Georgetown Charter Township

Planning Commission Meeting Agenda

7.I. (PUD2003) Wesco Inc. (36th Ave./Baldwin PUD), Is Requesting Preliminary (For This Parcel Only Since The Preliminary Approval Has Expired And The Rest Of The Site Has Already Been Developed) And Final Planned Unit Development Approval For A Vehicle Service Station And Convenience Store On P.P. # 70-14-17-100-024, Located At 7661 36th Ave., Georgetown Township, Ottawa County, Michigan.

7.I.ii. (PUD) Wesco Staff Report

SOUTH ELEVATION
 1/4" = 1'-0"

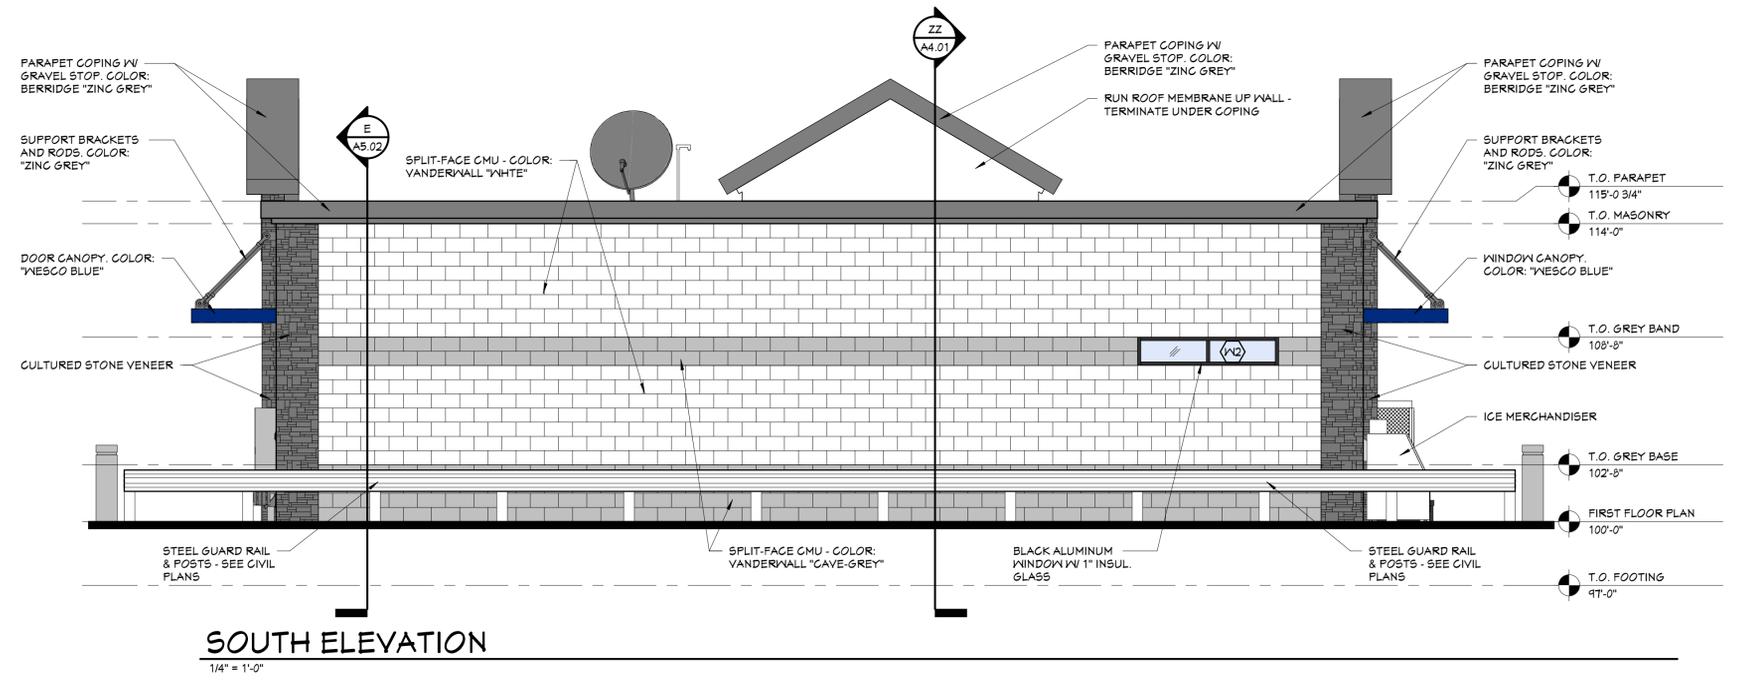
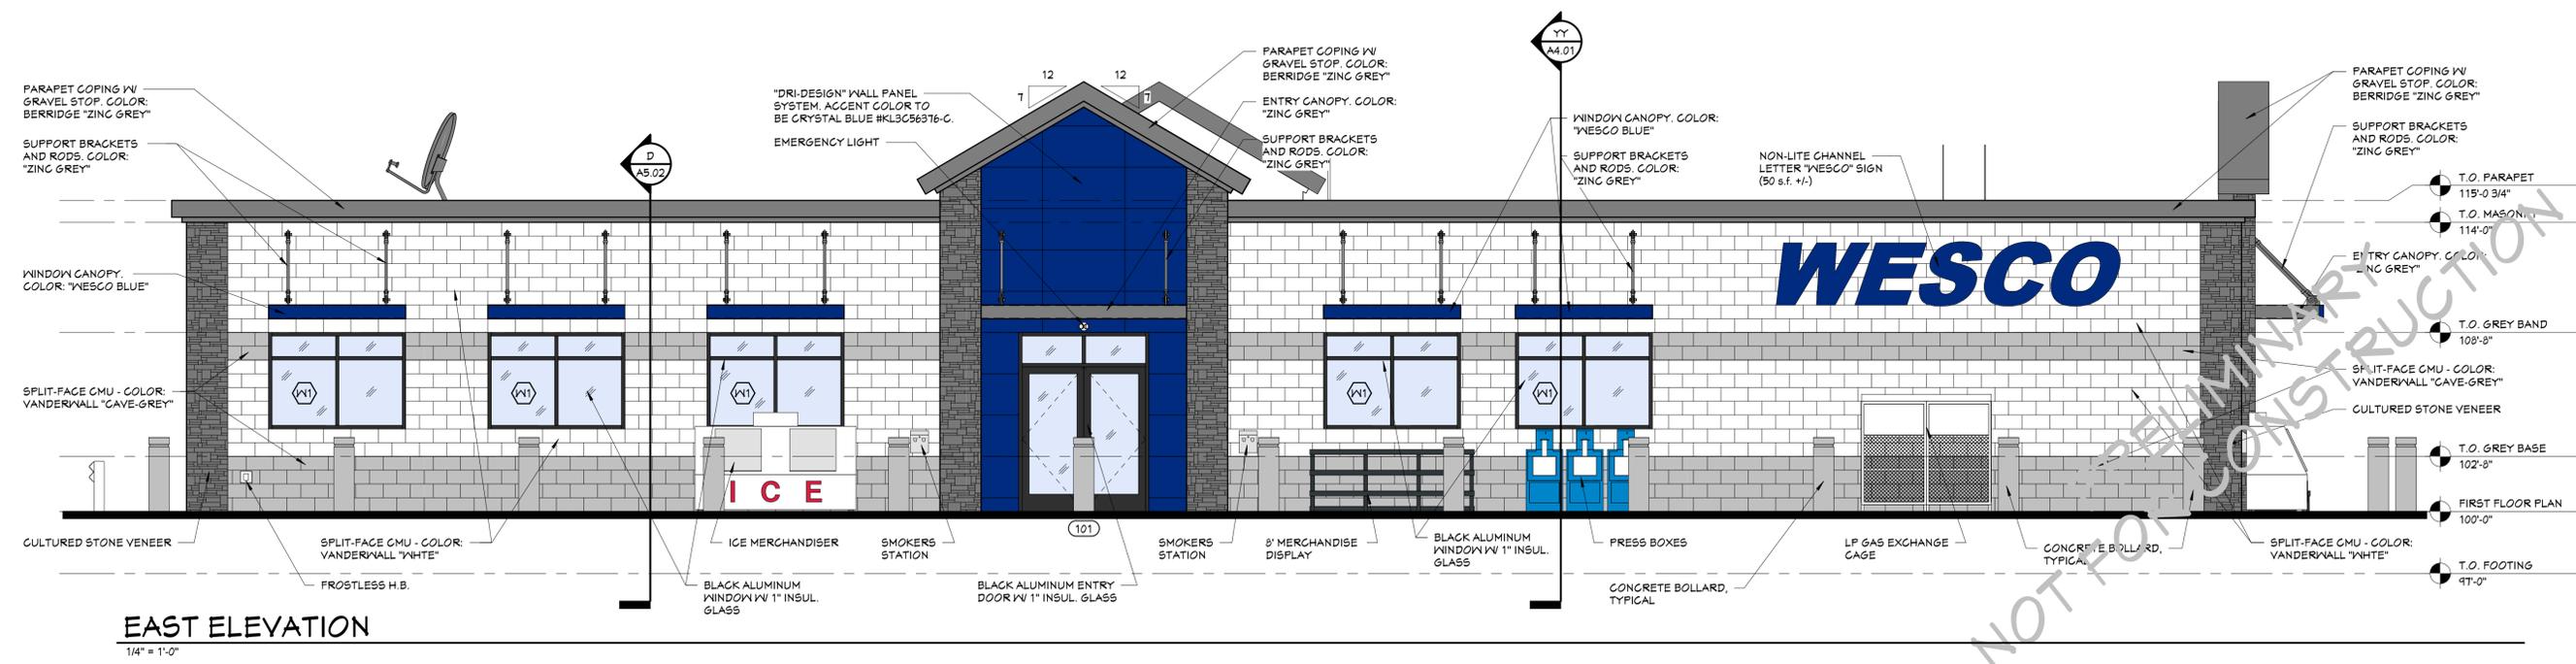
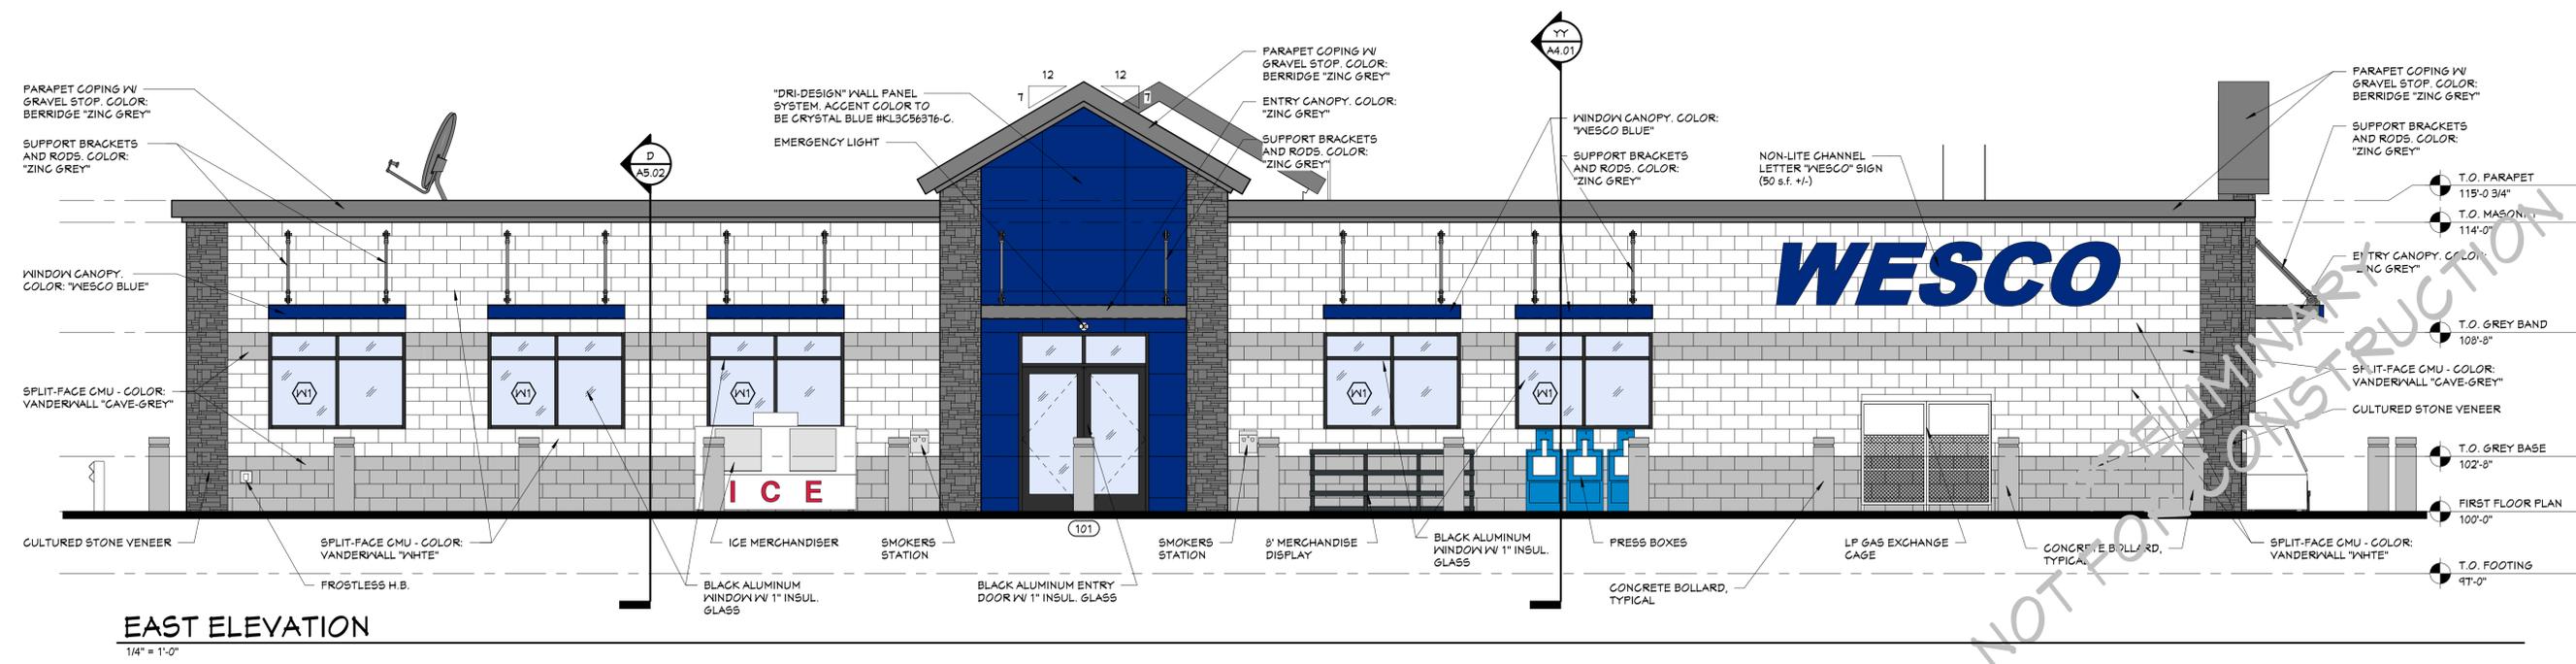
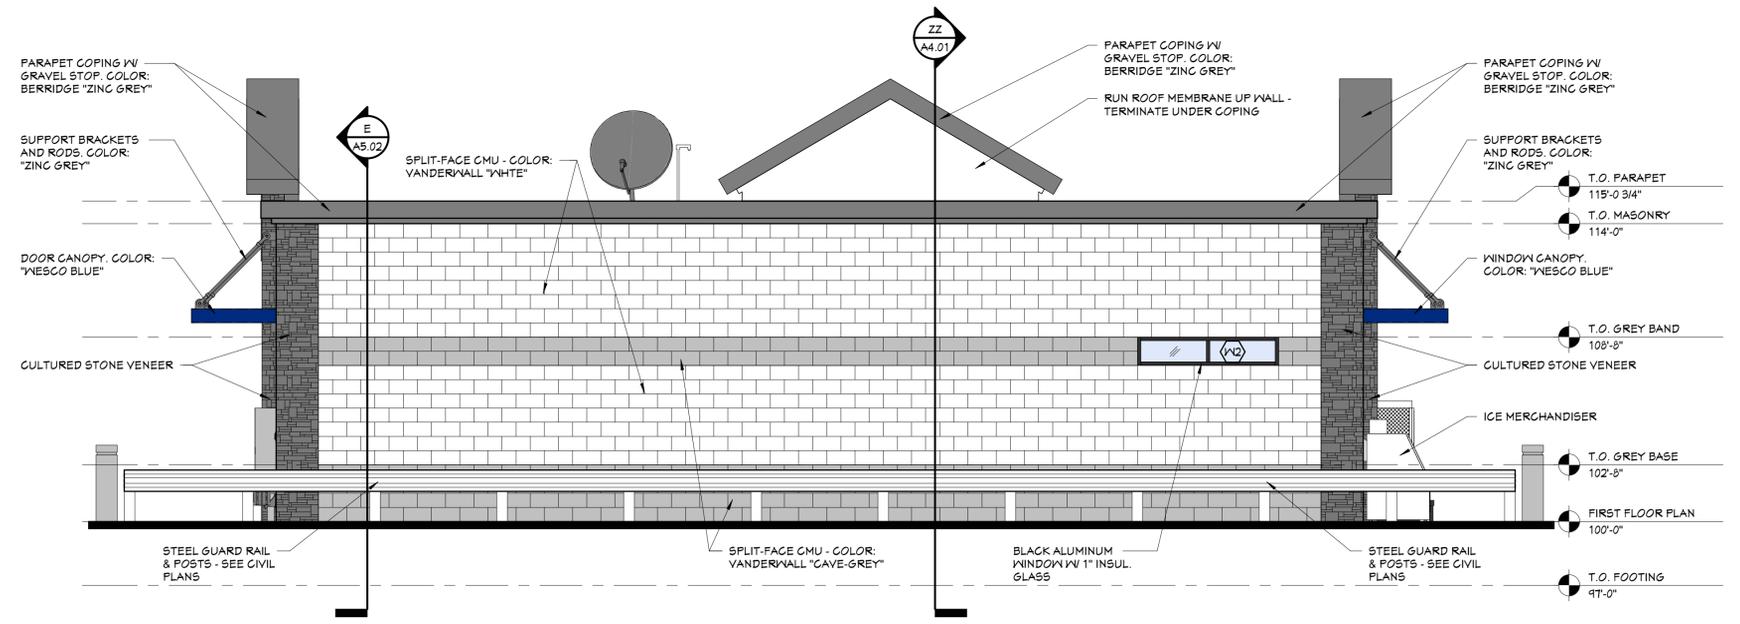
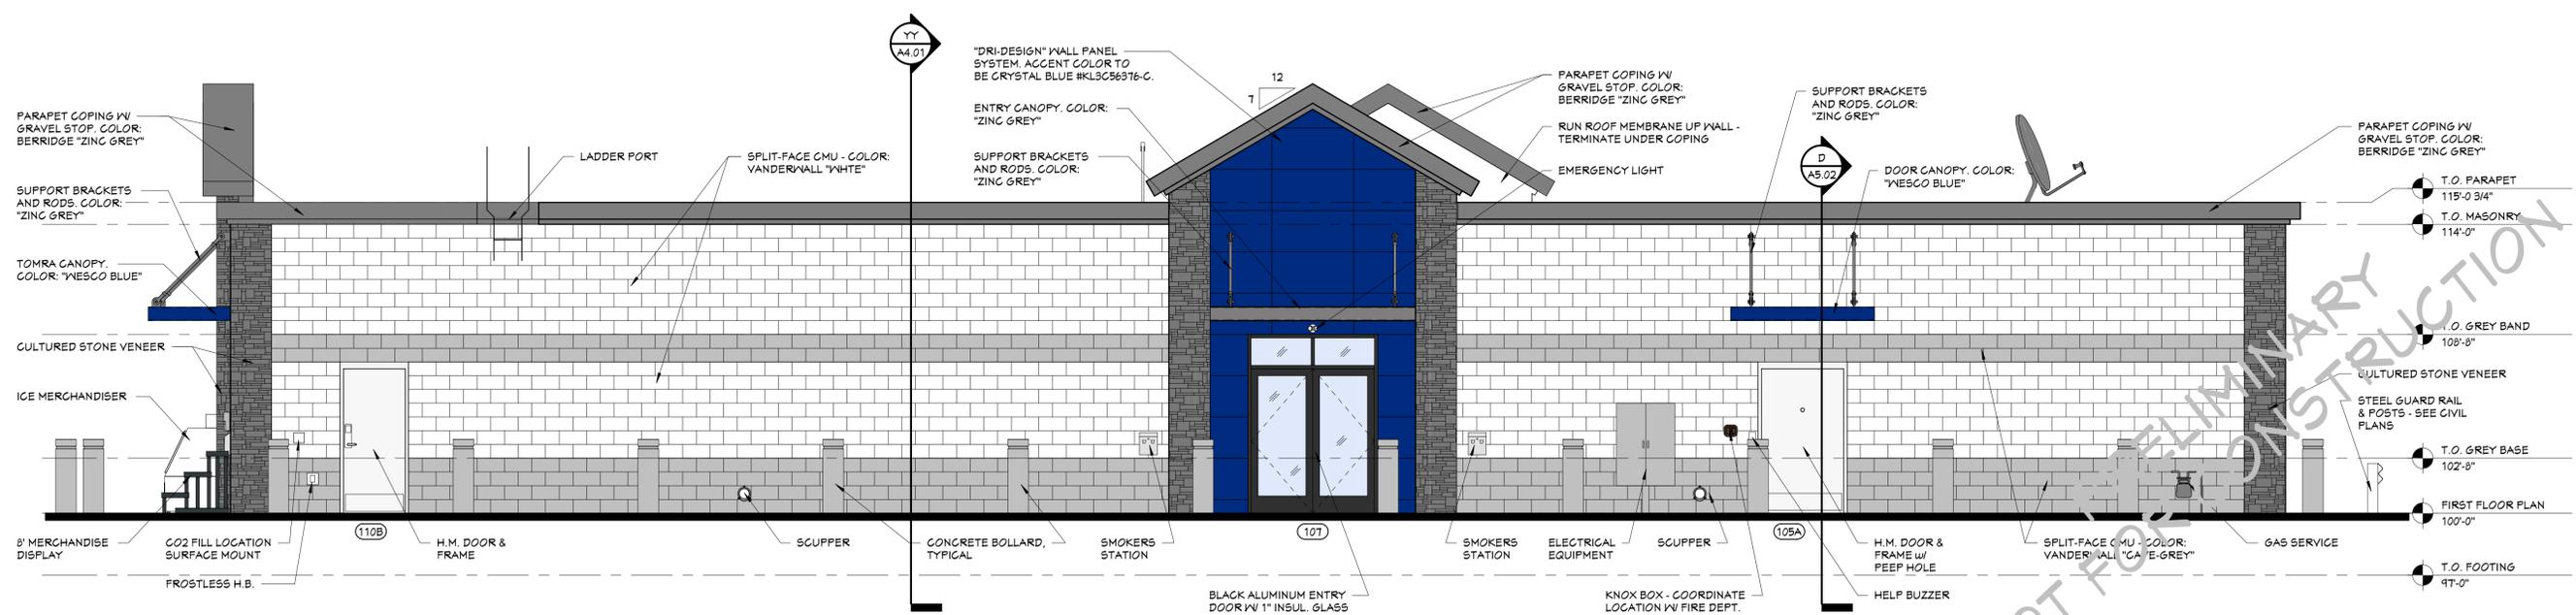
The proposal appears to be consistent with the Master Plan and Future Land Use Map for the use. The Planning Commission will have to determine if the architectural character is consistent with the Licari building and the other buildings/structures in the PUD.

The Planning Commission will have to determine if the architectural character is consistent with the Licari building and the other buildings/structures in the PUD..

- f. Existing and proposed topographic contours at a maximum of three (3) foot intervals. **PROVIDED.**
- g. Elevation views of all proposed structures and floor plans for all multi-family residential dwelling units. **PROVIDED. The Planning Commission will determine if the architectural design meets ordinance and Master Plan requirements.**
